ARCHITECT'S ADDENDUM No. 003

Project: PFISD Campus Modernization – Phase 3
RA# 2407.1
Owner: Michael Porter
2021Crystal Bend Dr
Pflugerville, TX 78660
Architect: Reliance Architecture, LLC
12 Chisholm Trail, Suite 200
Round Rock, TX 78681

Date of Issuance: January 31, 2025

Addendum to the Drawings and Project Manual dated January 17, 2025.

FLOOR FINISH PLAN DESSAU A8.02

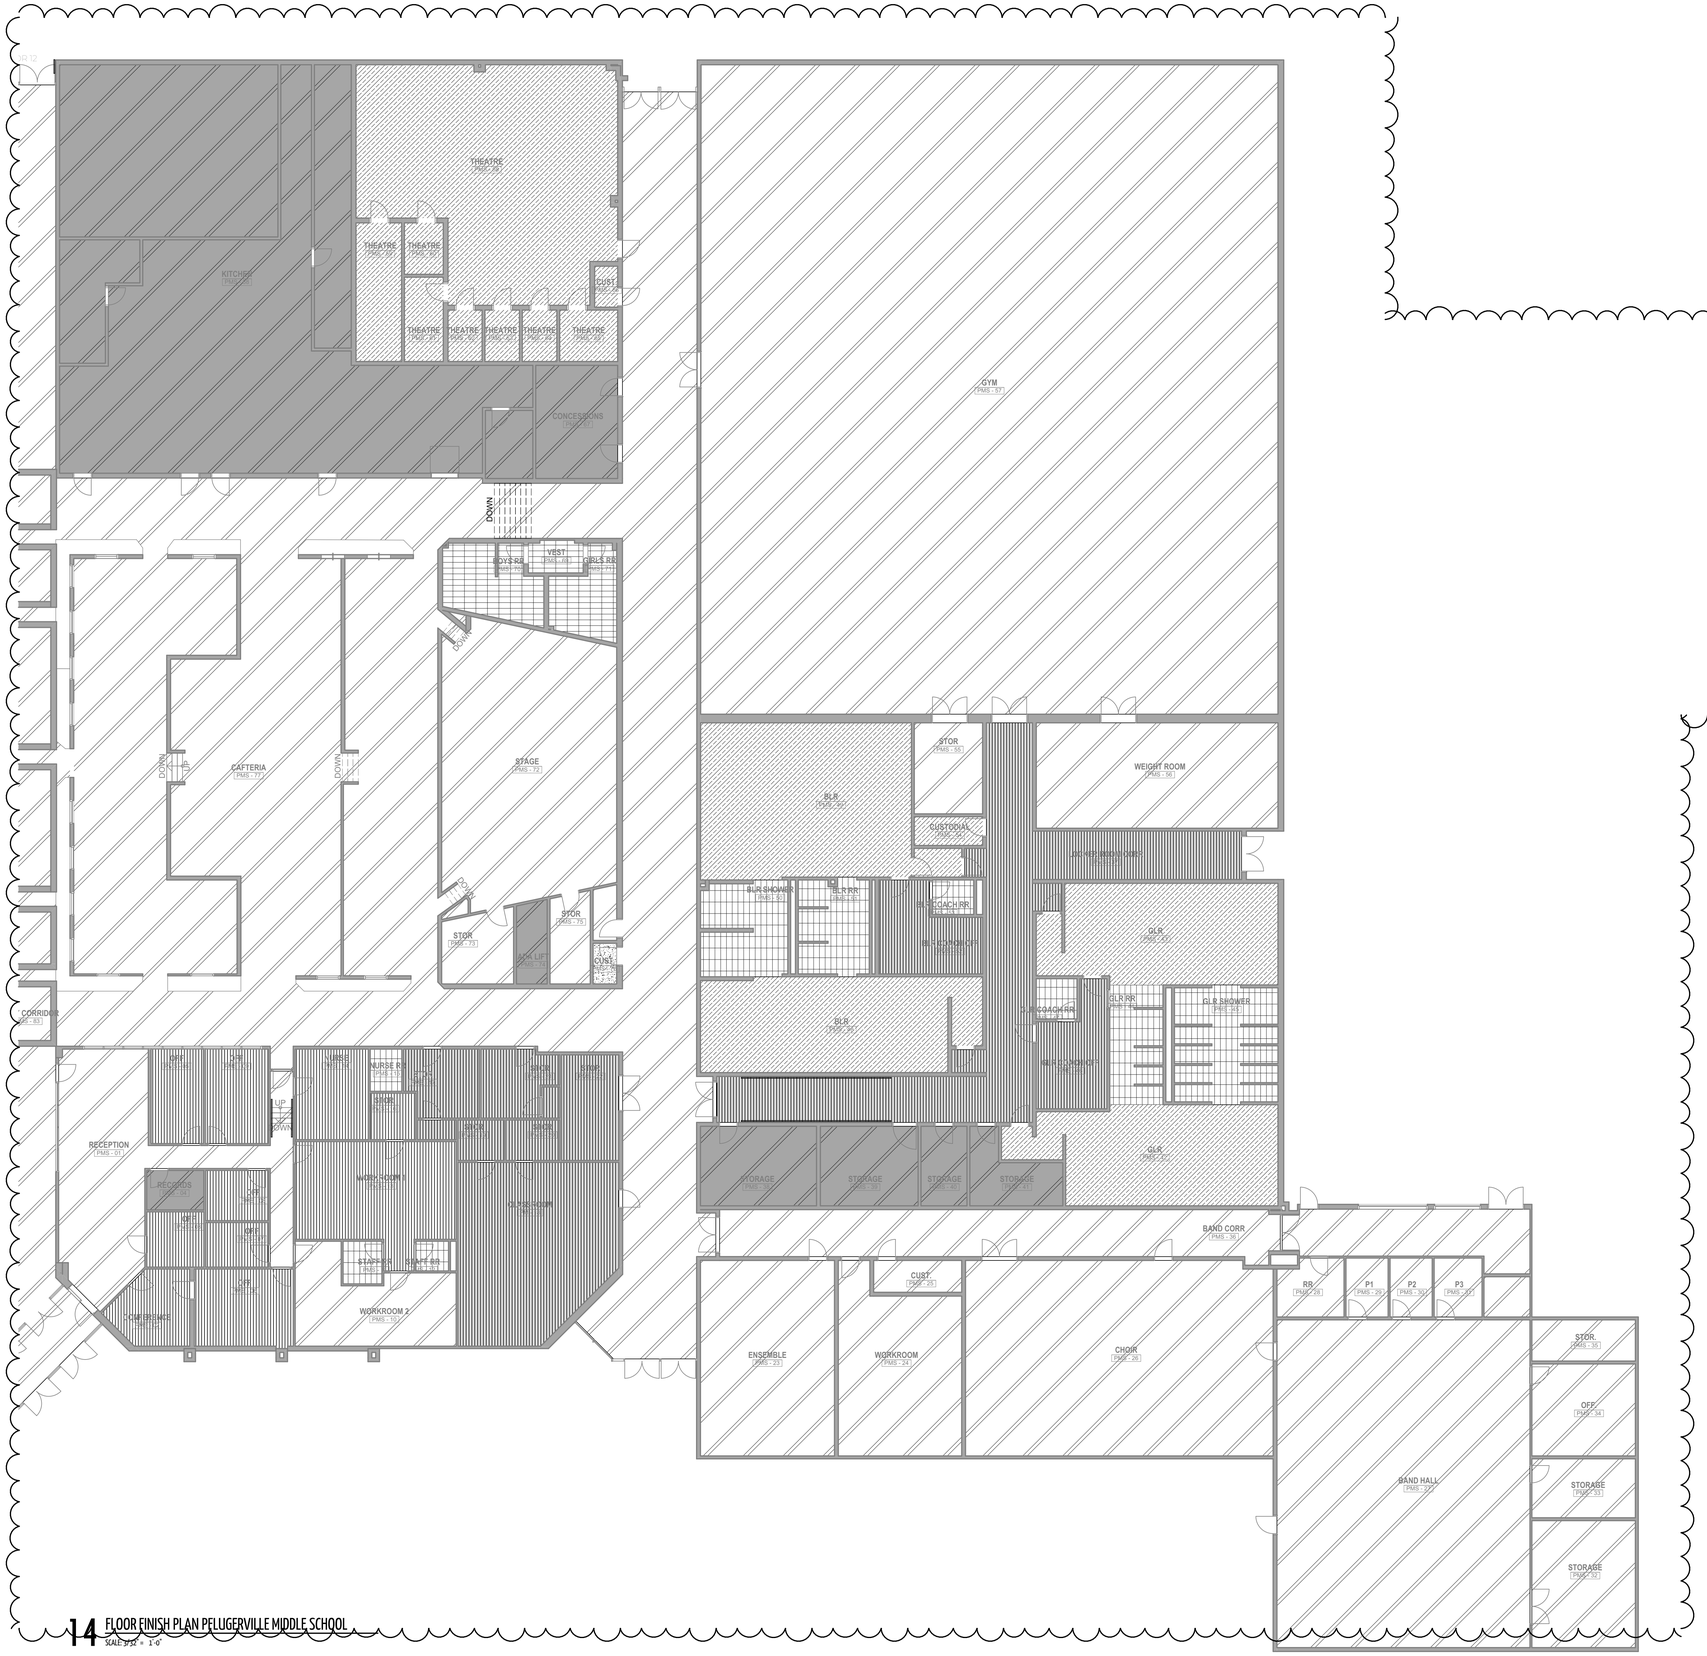
A. Updated finish floor legend.
B. Added dimensions for floor patterns

C. Changed sealed concrete to epoxy in athletic locker rooms per owner's request
D. Added note for flooring graphics in cafeteria.
